# INDEX TECHNICAL SERVICE BULLETIN

PRODUCT:
ABBOTT PRISM® (82)

# TECHNICAL SERVICE BULLETIN

Version 2.5 Software Upgrade

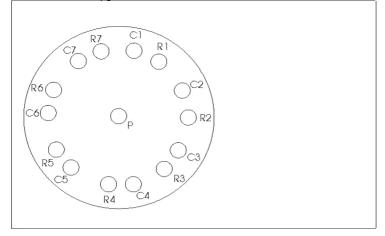
- 5. Replace Channel 2 Purge Valve with Ceramic Purge Valve.
  - a. Remove old purge valve (RR-D2).
  - b. Remove purge valve mounting standoffs. It will be necessary to start unscrewing with a wrench. Once the stand off starts to move oil the threads with super lube. Finish unscrewing the posts by hand because it is very easy to break the standoffs when unscrewing. A kit (Purge Valve Tools, 1-14207-01) is provided if you do break the stand off. The kit contains a drill bit, a tap and a tap handle.

- c. Install new purge valve mounting bracket (2 screws) and ceramic purge valve.

Note: The tubing connections to the Purge Valve will be made during the checkout portion of this TSB.

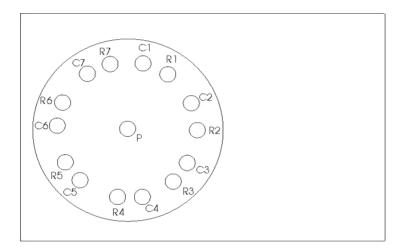
Connect a bottle containing purge solution to the conjugate reagent tube in the refrigerator. Using Pump Test in Component Diagnostics, cycle the pump 99 times to prime it (ignore errors while priming). Cycle the pump an additional 15 times and check for errors. If errors are present, troubleshoot accordingly (reference service manual). If no errors, then continue.

f. Connect the conjugate wash tubing to the purge valve.

28CW to C2

Figure 1

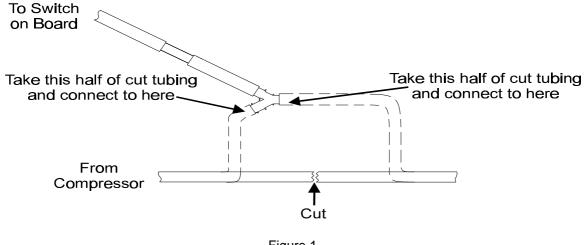
7. Cut each of the tubes from the compressors at the point where it will meet the tubing from the switch. The length will vary depending what is needed to properly route the tubing. You will need to route the tubing so that the tubing is not bent and that it does not stick up above the top of the compressors. Install the piece of tubing from the compressor to the Y connector of the tubing that goes to the switch on the Pump driver board as shown in figure 1. The other half of the tubing that you cut (the tubing with the letter label on the other end) goes to the "Y" connector as shown in figure 1.

# D. Mode Switch Assembly Installation on channel 6

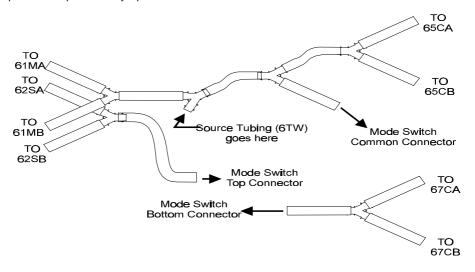
All of the following steps in this section are performed on Channel 6 unless otherwise specified.

- Remove the Air Tip Wash source tubing (should be labeled 6TW) for Channel 6 from where it connects to the first "Y" connector. Remove the rest of the Air Tip Wash tubing from channel 6.

Figure 1

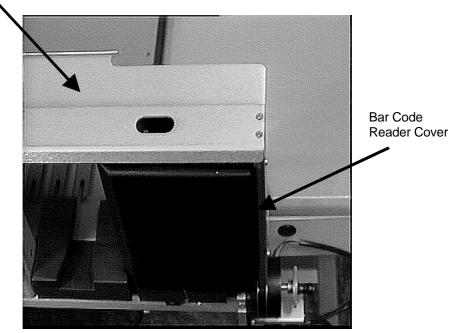
See Figure 1 for the following 3 steps.

Fig. 1

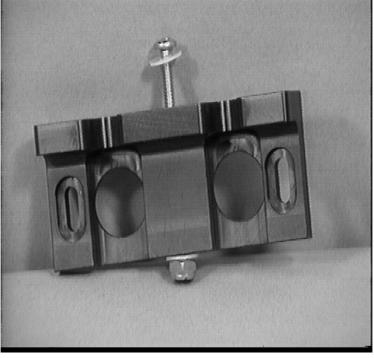
- 1. Assemble the new tip/grip stripper.
  - Remove the 2 inch screw, 2 nylon washers, black tip gripper, and nut from the kit.
  - Place 1 nylon washer on the 2 inch screw. Insert the screw through the vertical center hole of the black tip gripper. The head of the screw and washer should be on the wide side of the tip gripper. Place the second washer on the screw. There should be a washer on the top and bottom of the assembly. See Fig. 1.

Fig. 2

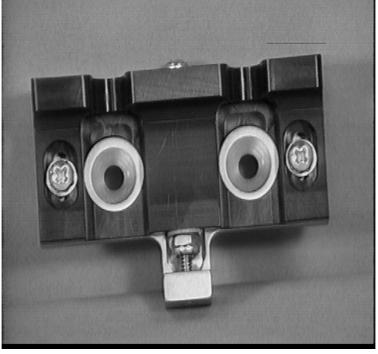
- Remove the gold colored mounting bracket from the kit. Lay the black, tip gripper onto the
    mounting bracket. The center screw hole of the mounting bracket should be at the bottom
    of the assembly by the nut. See Fig. 2.

Figure 1

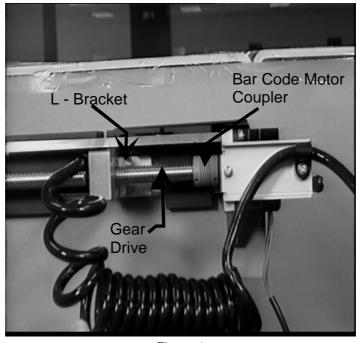
See Figure 1 for the following 3 steps:

- 5. Tighten the 2 set screws on the flat portion of the shafts. Tighten the remaining 2 set screws.
- 6. Tighten the 2 screws on the long portion (top) of the L-bracket.
- 7. Tighten the 2 screws on the short portion (underneath) of the L-bracket.
- 8. Manually move the rack loader (using the motor handle) to position 1 and back to home. If the motor binds, stop turning the handle, loosen 1 pair of screws on the L-bracket, and then tighten them again. The L-bracket may be bending the gear drive; thus, causing the binding. Loosening and then tightening the 2 pairs of screws on the L-bracket should align it.
- 9. Replace the Rack Plate Assy.
- 10. Replace the Barcode Reader Assy, as mentioned in step above.

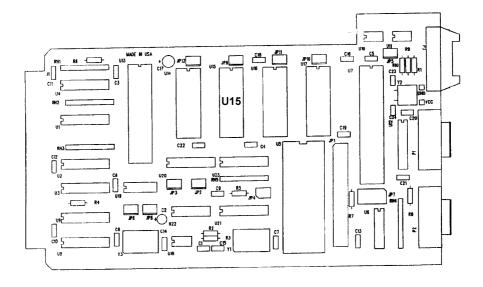
- Insert XY Axis Controller CPU Board into the XY Axis Controller Assy.
   NOTE: Verify board is fully seated.
- 2. Connect 2 cables to XY Axis Controller CPU Board.
- 3. Secure XY Axis Controller CPU Board to XY Axis Controller Assy (1 captive screw).
- 4. On top side of Magnon Controller locate manufacturer's serial number and Rev. level of XY Axis Controller assembly.
- 5. On this sticker locate the Revision letter or Revision letter and date, depending on the sticker type.
- 6. With a permanent marker, mark through the Revision letter and date (if applicable).
- 7. Adhere new Rev. F level sticker below manufacturer's sticker.
